Thank you for contacting the City of Sammamish regarding the current Shoreline Substantial Development Permit Application for East Lake Sammamish Trail [Segment 2B \(SSDP2016-00415\)](#).

East Lake Sammamish Trail Railroad Right of Way Historical Acquisitions

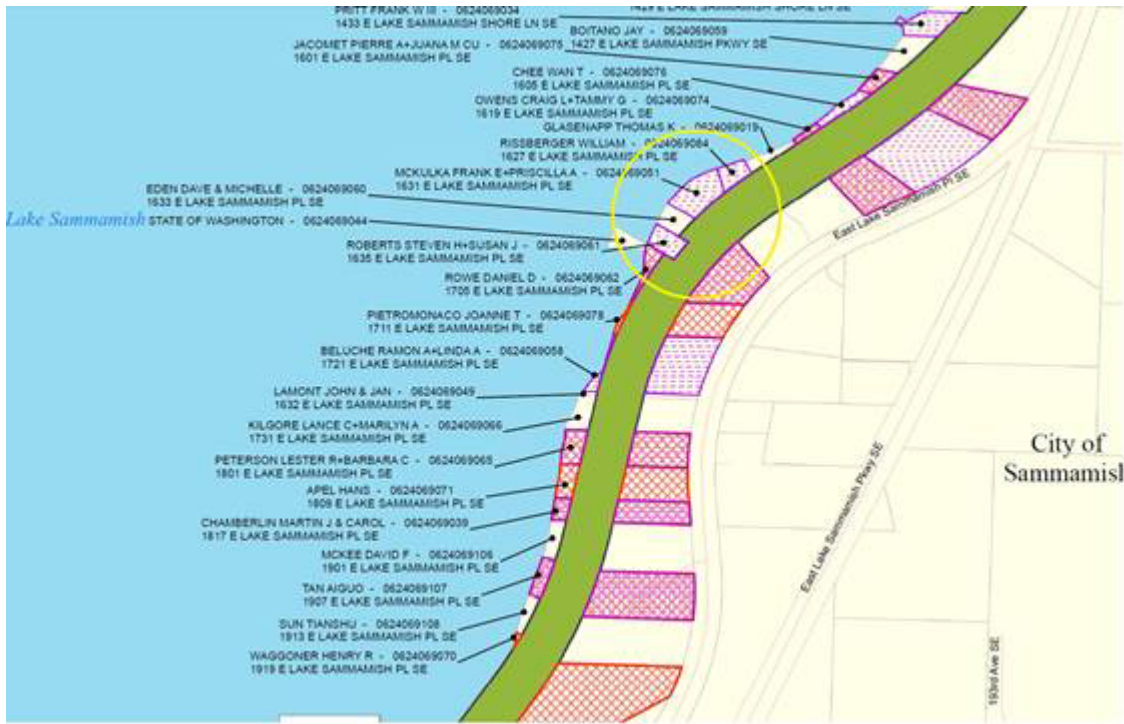
Attached is a county produced map of the area. For clarity here is an annotated blow up of that map showing the 4 homes affected in this discussion.

In general here is the list of my concerns with widening trail west past its current position.

1. The current crossing point for the trail would be narrowed at the Rissberger property (1627 E.L.S. PL SE) making general access even more precarious.

2. Myself (1635 E.L.S. PL SE) and the Edén's family (1633 E.L.S. PL SE) when leaving our properties must back out and back into the McKulka property's driveway (1631 E.L.S. PL SE). This becomes even more difficult with a west widening of the trail.

3. Currently there is just enough room for driving past the Edén's parked vehicles for me to access my property. If the trail is widened west then that will be impossible without some major changes to where/how the Edén's currently park.

4. If the trail is widened west then that tree as shown in the picture will have to be removed so that I can get to my property. That would be a shame. Not only for those neighbors that enjoy the tree but for the eagles that often use it as a perch.

Roberts Residence
 1635 E. Lake Sammamish Pl S.E.
 Sammamish, Washington 98075
 Parcel #: 062406-9061
SITE PLAN

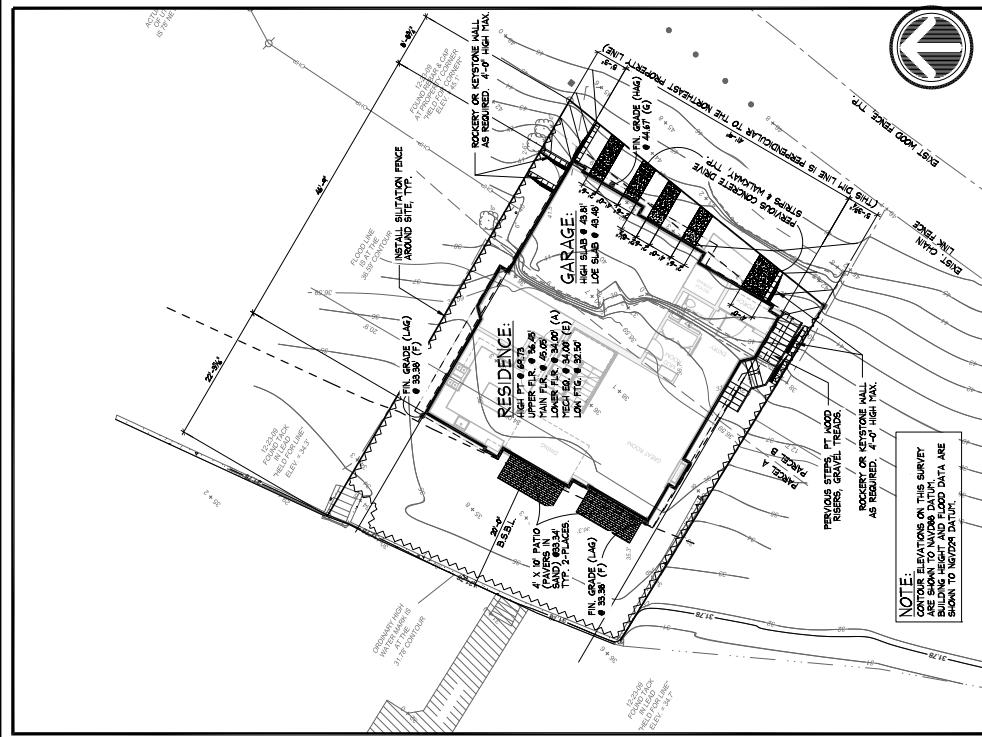
In that regard I would like to meet with you and/or Steve Leniszewski to review my specific ingress/egress concerns regarding my home which was permitted based on a requisite safe turning radius to access my garage. How can I set up an appointment with you?
